# Technical Bulletin

Section Title: Engine  
 TSB No. TS 28 07140R

**SUBJECT:** SAFETY RECALL CAMPAIGN: SB, POWER STEERING TENSIONER PULLEY DAMAGE.  
**MODEL(S):** XL-7 (JA627), GRAND VITARA (JB627)  
**YEAR:** XL-7 2005~2006, GRAND VITARA 2006  
**VIN RANGE:**

**Inspection of Tensioner Pulley**

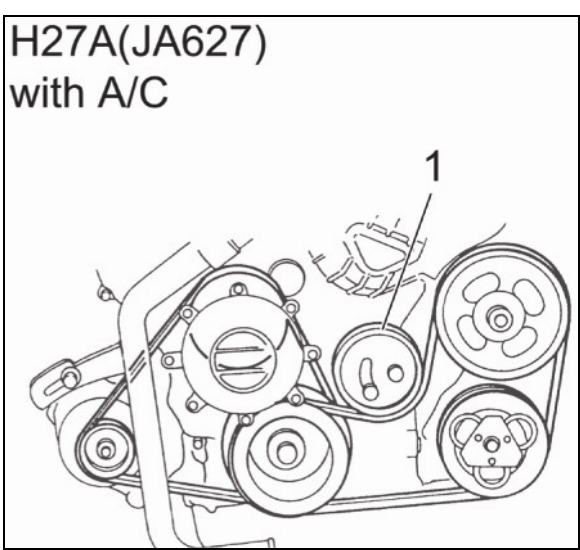
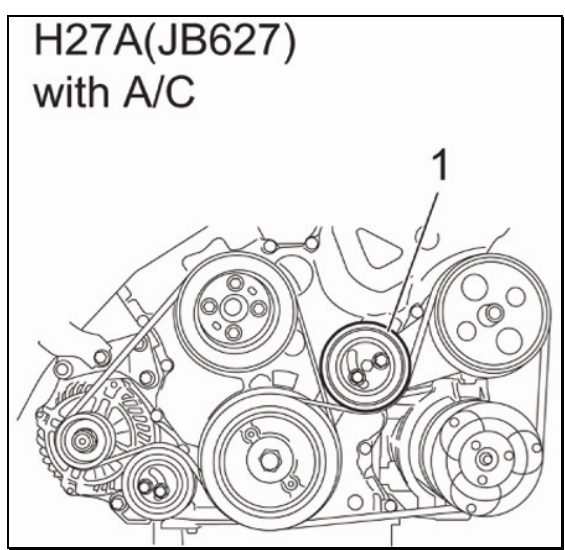
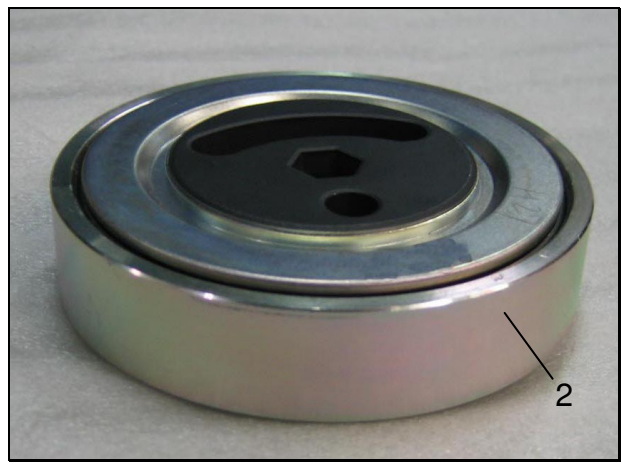
- 2. Visually check the tensioner pulley (1) outer race to determine if it is plastic or steel.

3. They can be easily distinguished by checking the color of the outer race.

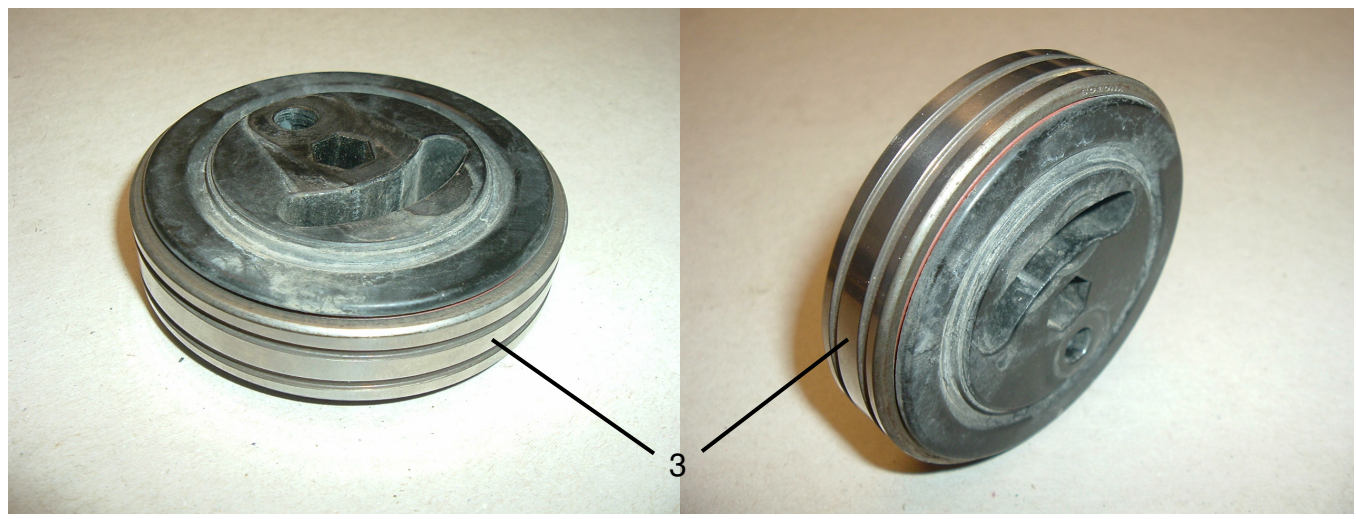
Black: Plastic outer race (1)  
(Replace)

Silver: Steel outer race (2)  
(Do Not Replace)

Failed: Black plastic outer race missing (3)  
(Replace, this Does Not Pass inspection as OK)

## Replacement Procedure

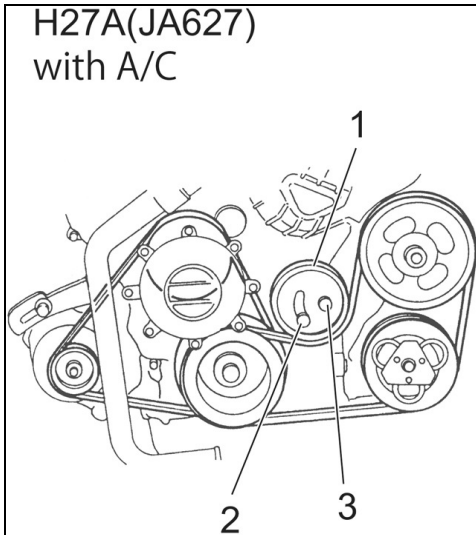
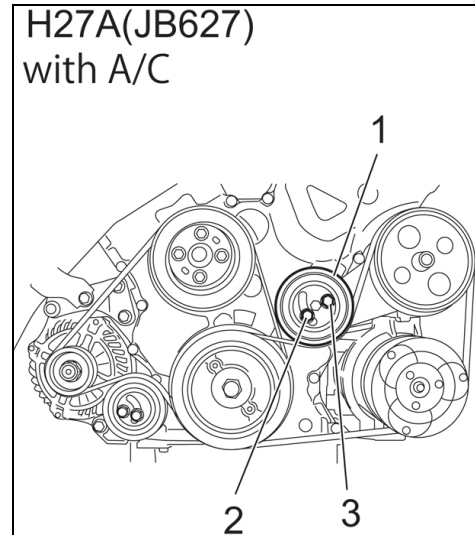
- To remove the **Plastic** Tensioner Pulley (1) from the H27A engine, loosen the tensioner pulley adjusting bolt (2) to relieve the tension on the power steering/AC belt, removing it along with the tensioner pulley bolt (3), and then the tensioner pulley.

- Install the new Steel tensioner pulley, tensioner pulley bolt (3) and adjuster bolt, tightening by hand. Based on which vehicle is being repaired and the available tools, select the applicable method to adjust the belt tension from steps 6, 7, or 8, listed below.
